SERVICE No. 1156 BULLETIN

Date: April 7, 2005

PERIODIC REPLACEMENT OF NOSE GEAR DRAG LINK BOLT

Figure 1
Typical PA-28R Bolt Location

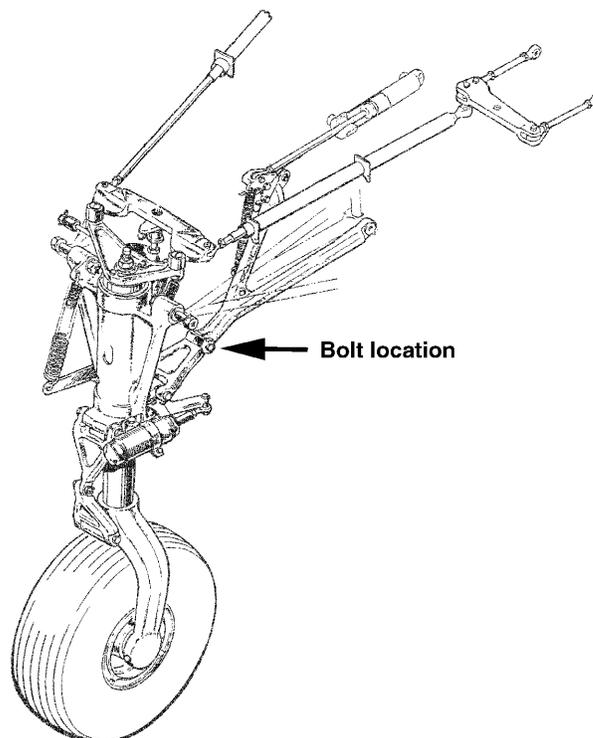
1. Jack the aircraft per the Aircraft Service Manuals/Maintenance Manuals.
2. Disassemble Upper Drag Link from Lower Drag Link, by removing the NAS464P4-27 bolt that functions as a hinge pin for the two parts. See Figure 1 or Figure 2 as applicable. Discard bolt and cotter pin, regardless of condition. Nut and washers may be reused, depending on condition.

3. Inspect bushings for excessive wear, and verify that bushing IDs are within Service Dimension range of .2515 to .2495 inches, replacing as necessary.

4. Reassemble Upper and Lower Drag Links per the Aircraft Service Manuals/Maintenance Manuals, by installing a new NAS464P4-27 bolt, taking care to reposition washers retained in Step 2. Reinstall castellated nut retained in Step 2. and secure with a new MS24665-134 cotter pin.
